CALVERT CLIFFS NUCLEAR POWER PLANT UNIT NO. 1

Amendment No. 100  
License No. DPR-53

ATTACHMENT TO LICENSE AMENDMENT NO.100

CALVERT CLIFFS NUCLEAR POWER PLANT UNIT NO. 2

CALVERT CLIFFS SITE BOUNDARY MAP FIG. 5.1-1

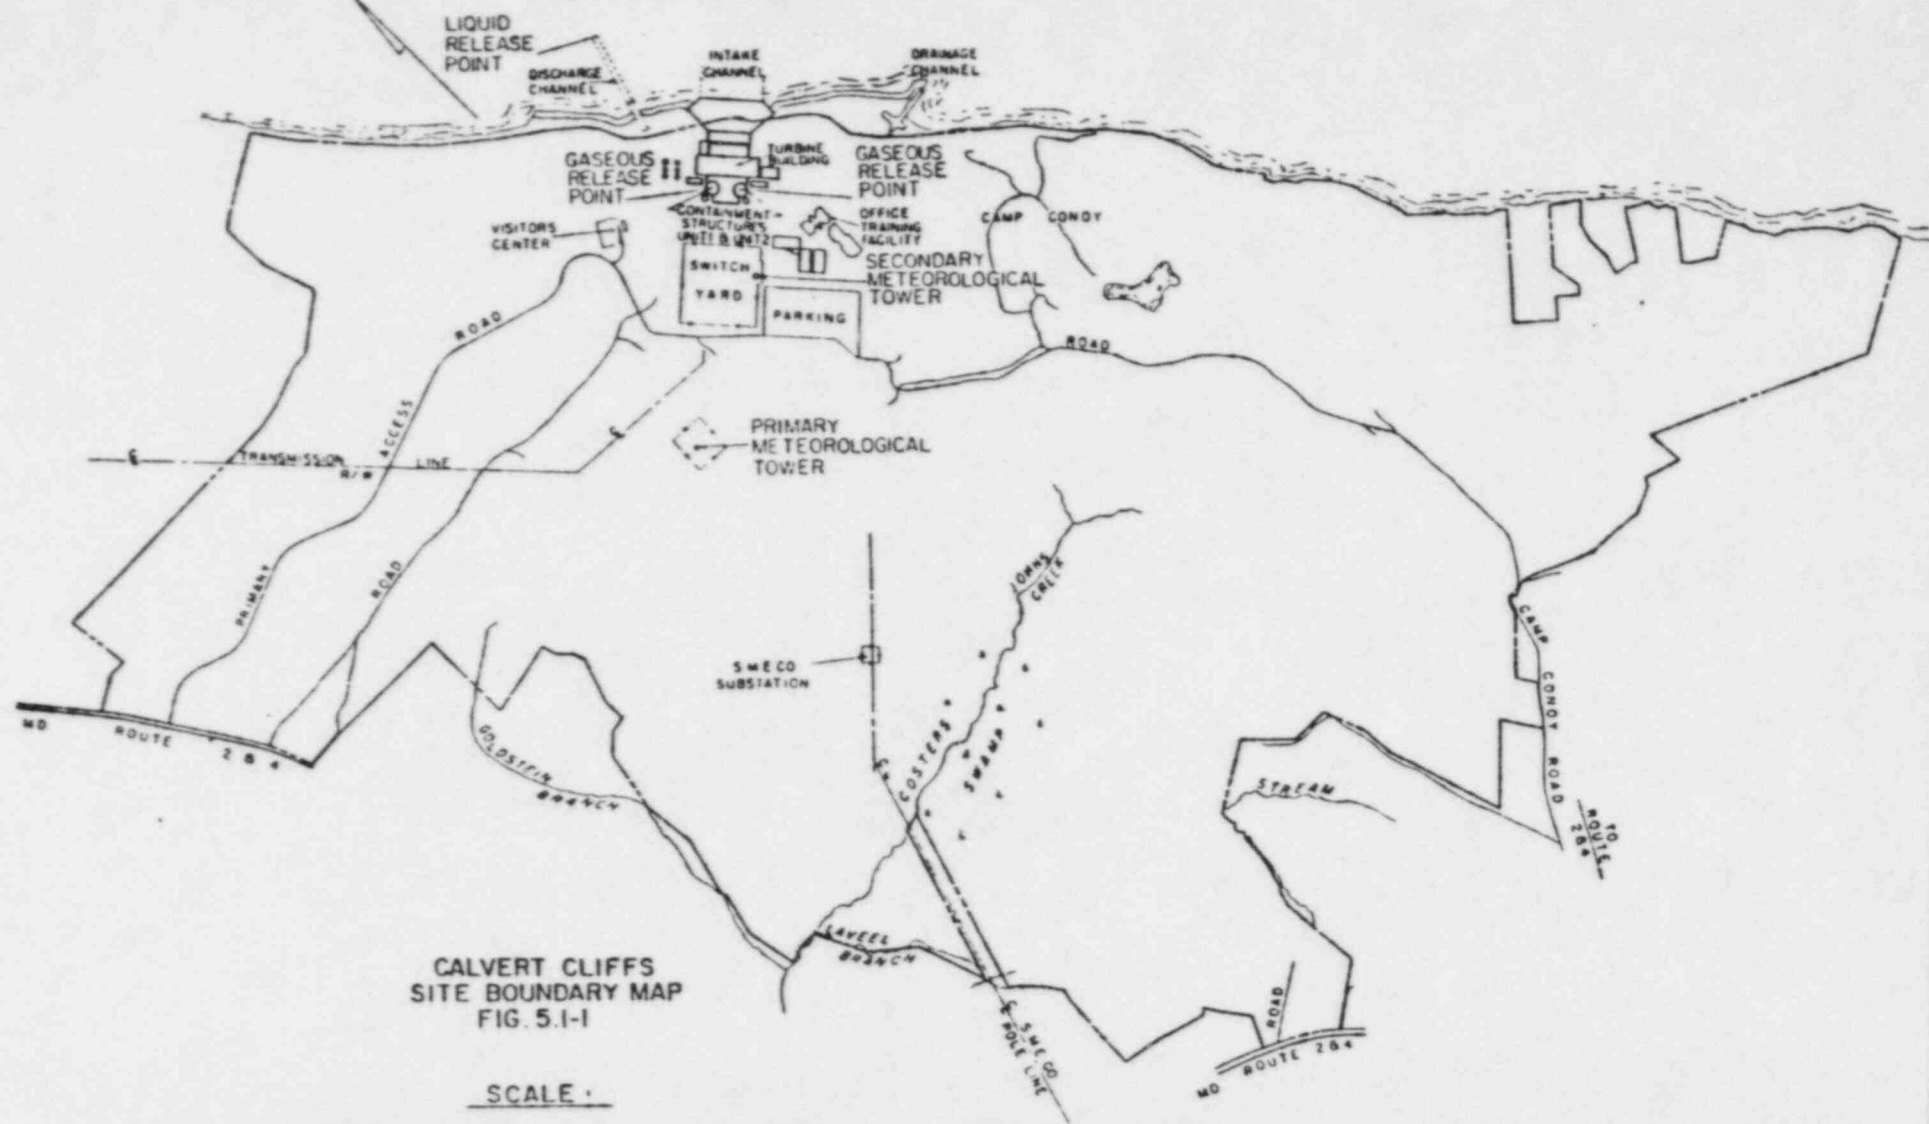
5.1.1 A map of the Calvert Cliffs Nuclear Power Plant site identifying the major plant structures as well as defining the radioactive effluent release points and the SITE BOUNDARY is shown in Figure 5.1-1.

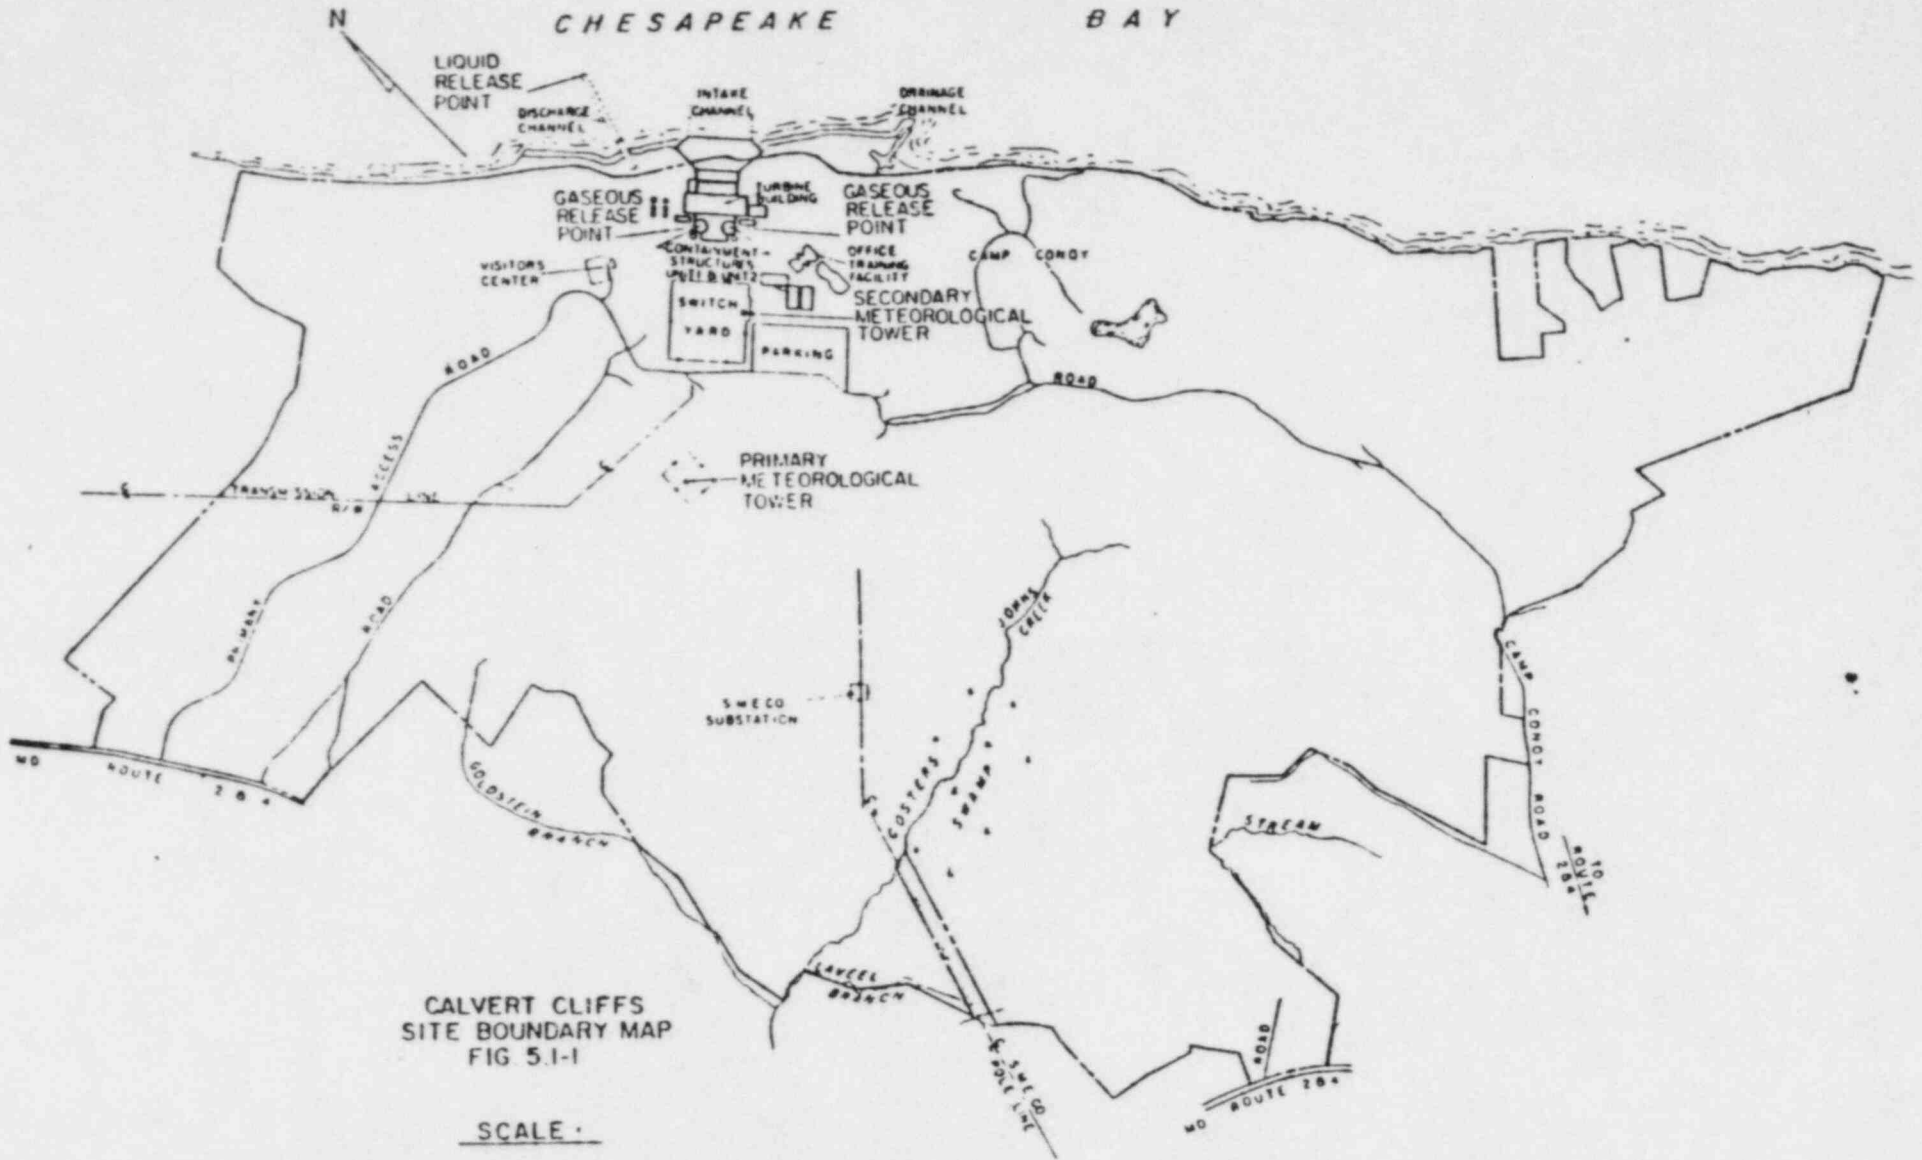
5.1.1 A map of the Calvert Cliffs Nuclear Power Plant site identifying the major plant structures as well as defining the radioactive effluent release points and the SITE BOUNDARY is shown in Figure 5.1-1.
